INSPECTION TICKET

APPL NUMBER: 13-50030947 CP NEW RESIDENTIAL (SFD) DIRECTIONS: T/S: 04/01/2013 02:07 PM VBROWN ----

STRUCTURE: 000 000 81X58 4BDR 3BATH SFD W GAR DECK CRAWL

Job	Truss	Truss Type	Qty	Ply	REGISTER@CUSTOMLot8809*506340	120964415
REG8809	D02	SPECIAL	7	1	Job Reference (optional)

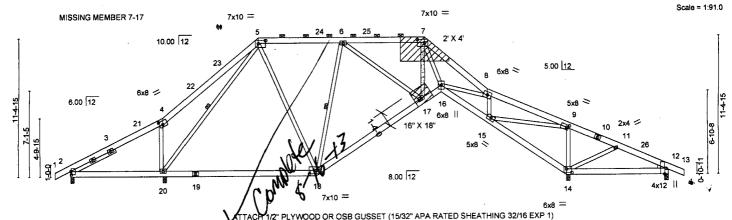
ADD 2 X 4 SP NO.2 **CUT TO FIT TIGHT**

AT IACH 1/2" PLYWOOD OR OSB GUSSEL (1932 APA RATED SHEATING S2TIG EAP TO EACH FACE OF TRUSS WITH 10d (3" X. 131") NAILS DRIVEN THROUGH BOTH SHEETS OF PLYWOOD AND CLINCHED PER THE FOLLOWING NAIL SCHEDULE:
2 X 3'S - 1 ROW, 2 X 4'S - 2 ROWS, 2 X 6'S AND LARGER - 3 ROWS: SPACED @ 0-4-0 O.C.
NAILS TO BE DRIVEN FROM BOTH FACES. STAGGER SPACING FROM FRONT TO BACK FACE FOR A NET 0-2-0 O.C. SPACING IN THE MAIN MEMBER. USE A MIN. 0-3-0 MEMBER END DISTANCE.
